CITY OF MERCER ISLAND

RE: Request for Information #2 for File No. SUB21-008 – Koneru Short Plat
6610 East Mercer Way, Mercer Island, WA 98040; King County Tax Parcel # 302405-9153

KONERU SHORT PLAT, SUB21-008

Re: Koneru Short Plat (SUB 21-008/CAO 22-003)
6610 East Mercer Way
Mercer Island, Washington

TREE RETENTION PLAN

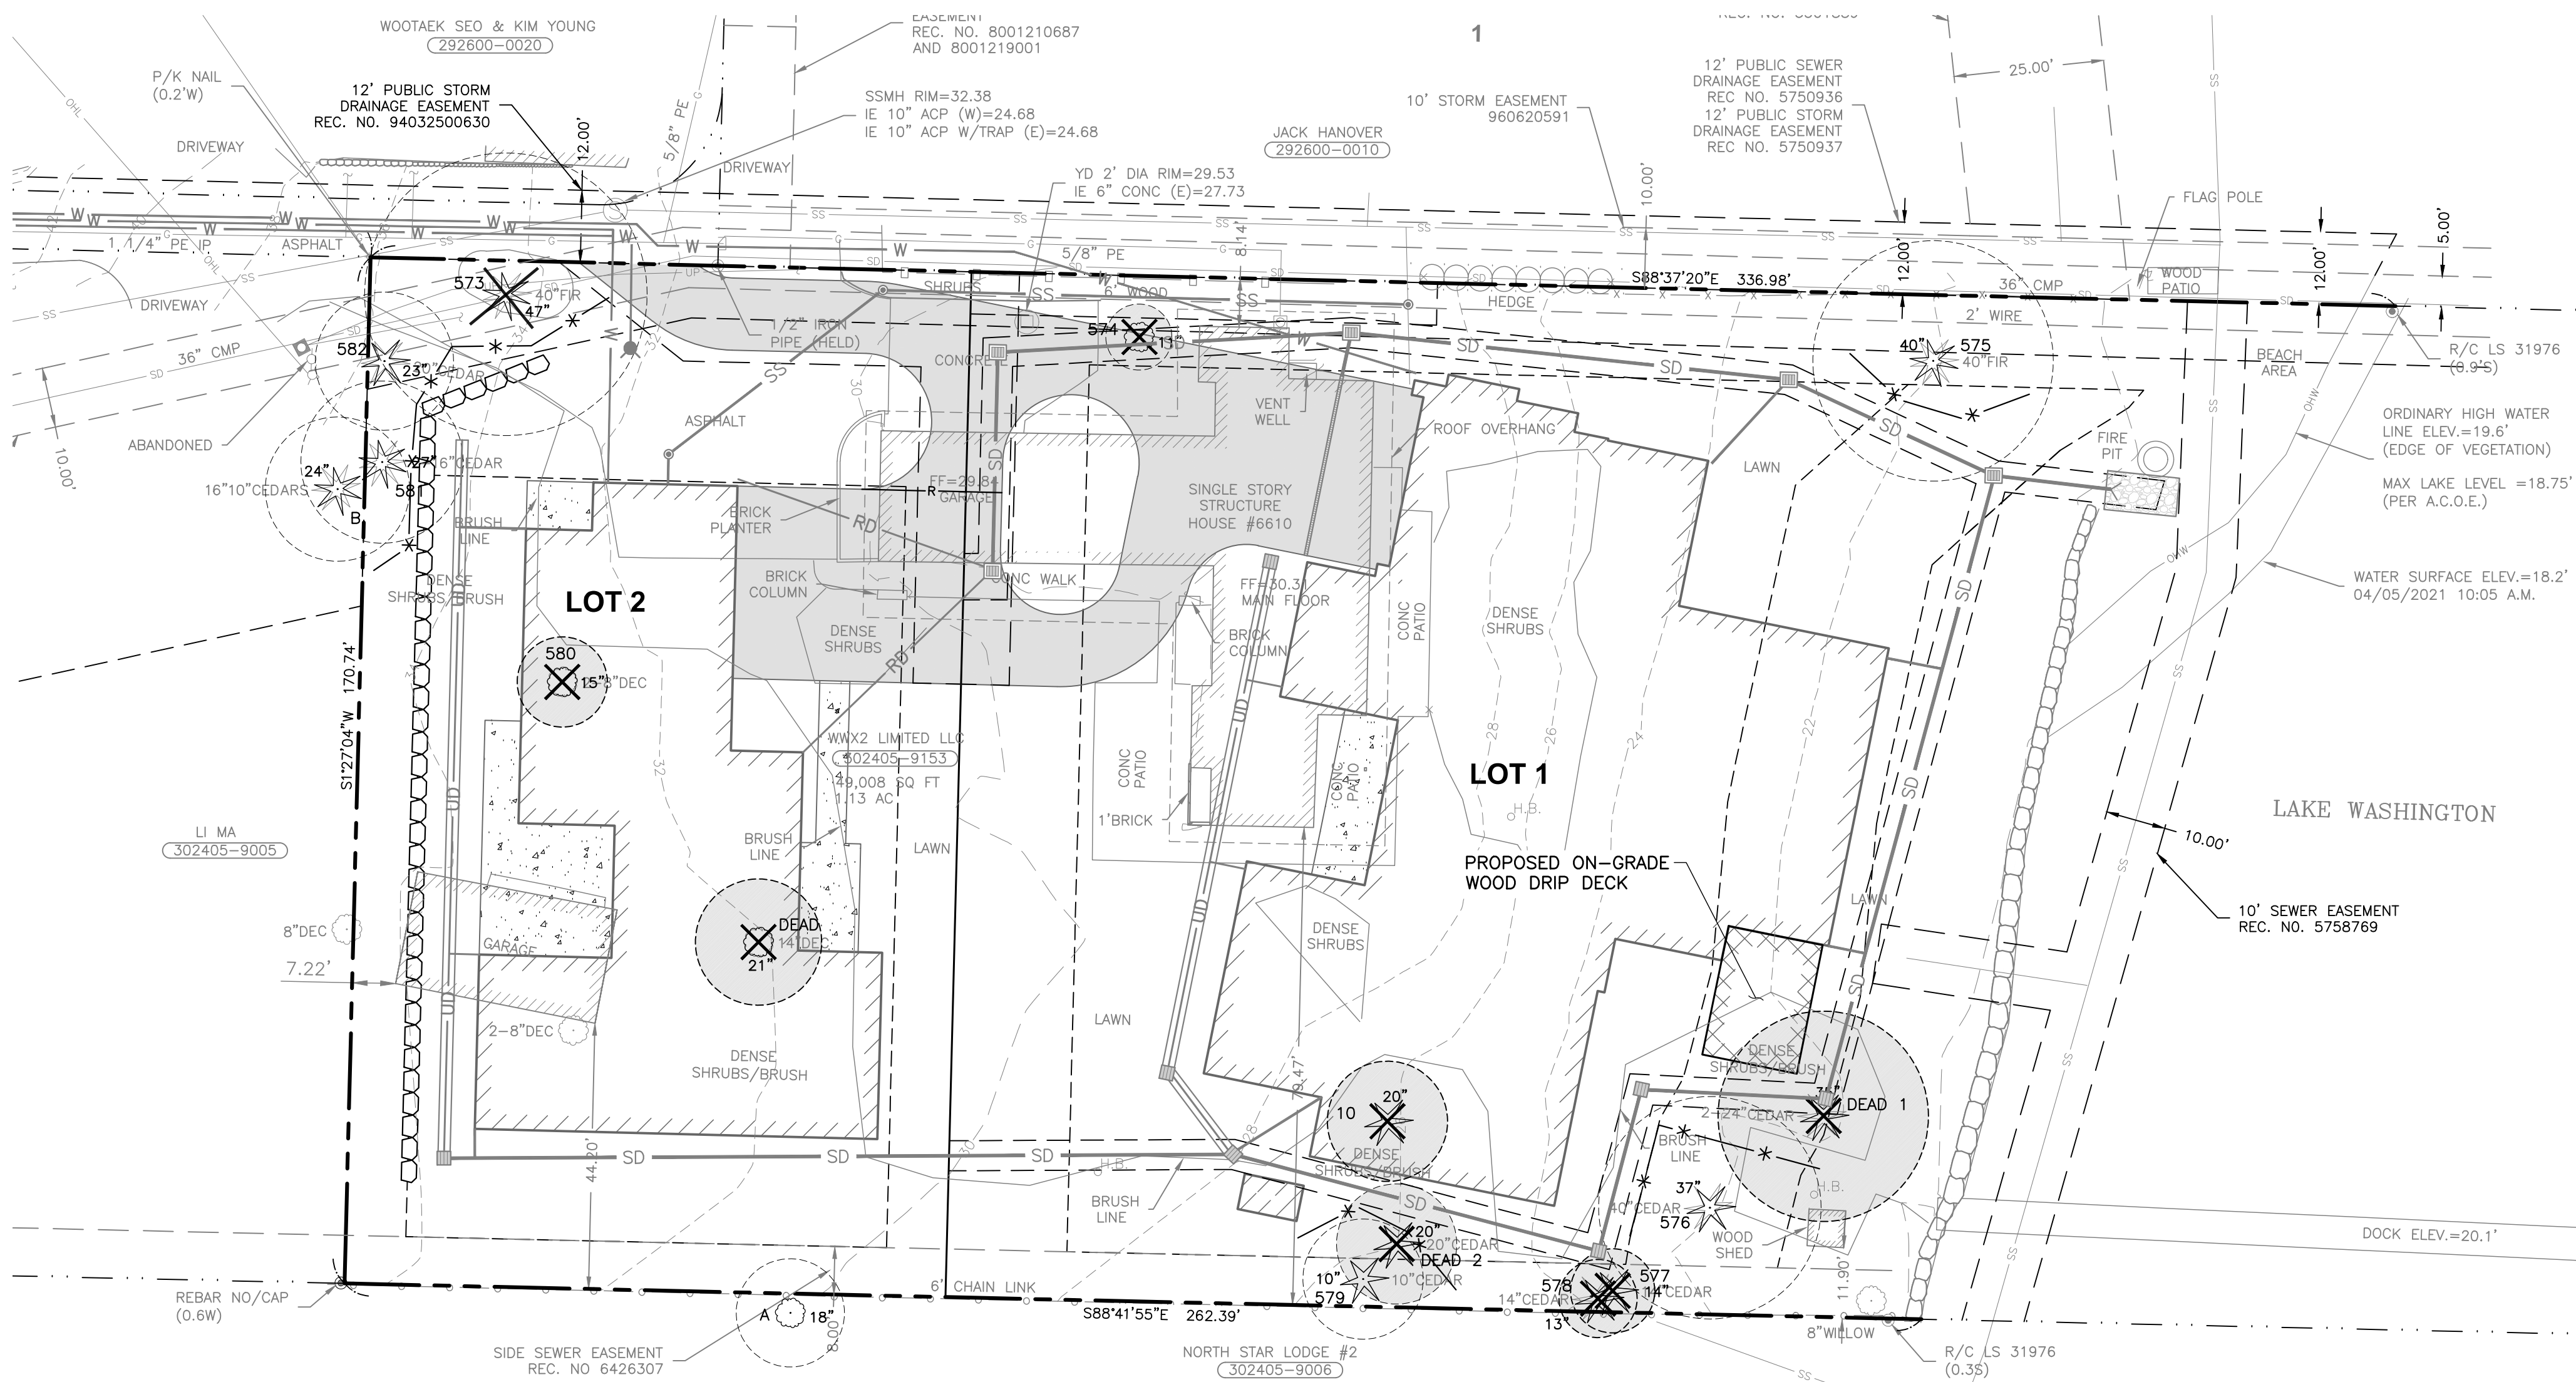
1. (Repeat comment for Architect/Arborist) provide Arborist evaluation that Dead Tree 1 would not have been damaged with the building pads encroachment into the tree's dripline. Even though this tree was already allowed for removal under a non-development tree permit. Since the tree was exceptional it would have been required to be retained and not damaged by development in the tree protection zone. This minimal excavation zone for the deck will be conditioned for the building phase.

3. (Repeat comment for Arborist) Update Arborists tree report, a draft report has been submitted. Arborist will need to review new plans and confirm the distance of disturbance is adequate and will not damage the saved tree.

4. (New comment for Civil/Arborist) because of change of plans Tree 573 is exceptional in size and now shown for removal. Fire had approved Sub 1. What has changed? The new hydrant is beyond the minimum recommended limits of disturbance. Please provide the access and hydrant requirements that conflict with the tree. Could some asphalt removal mitigate for the impacts of the new improvements?
